State of Ohio Environmental Protection Agency

September 29, 2008

RE: STARK COUNTY  
NIMISHILLEN TOWNSHIP  
PHIL'S PLACE  
6509 COLUMBUS RD.  
NPDES #3PR00469

Clarifier – note excessive solids.

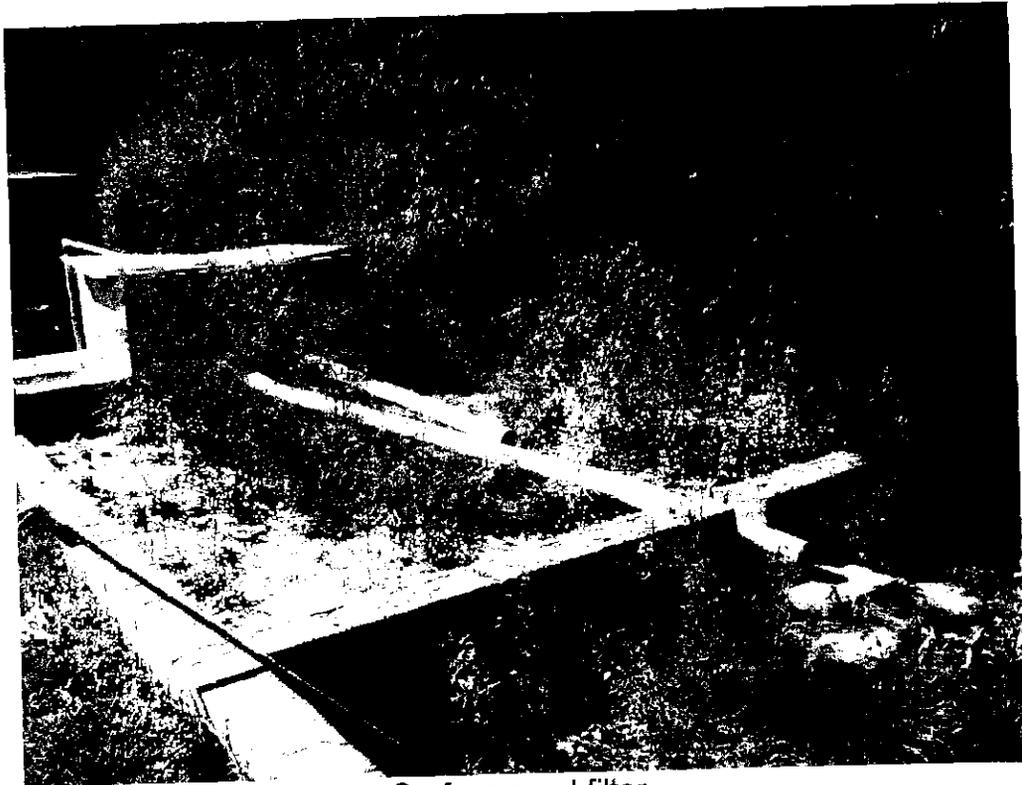
At the time of the inspection, the mixed liquor in the aeration tank had a light brown color. One sludge return was not operating. The sludge return must be made operable to return solids from the clarifier to the aeration tank so the system can operate properly. The contents of the clarifier were turbid. The surface sand filter beds contained excessive vegetation and need to be cleaned.

Chlorine contact tank

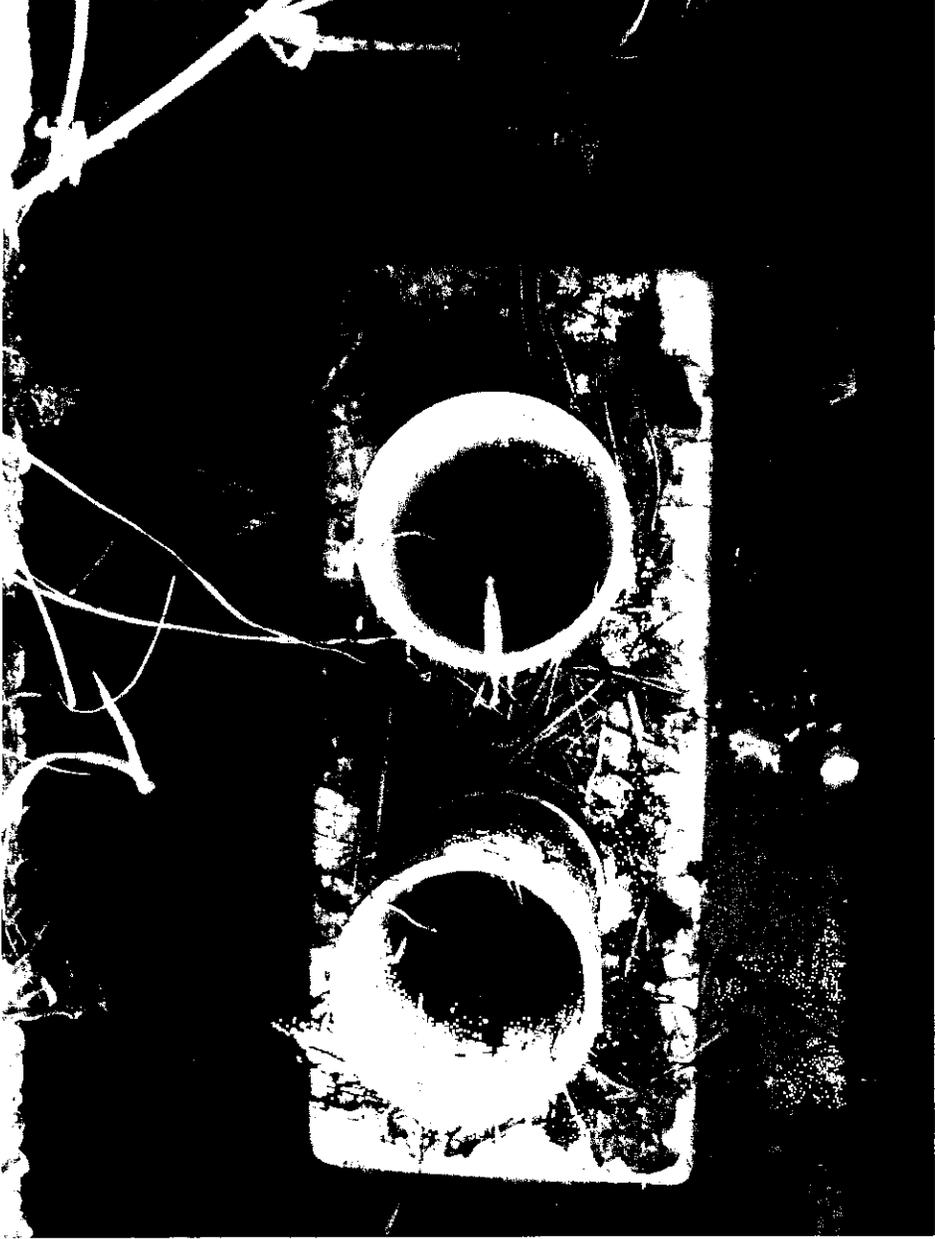
The chlorine contact tank was full of solids and the tablet chlorinator was empty. A tablet dechlorinator must be added to the treatment system. Overall, the plant is in very poor operation and maintenance condition.
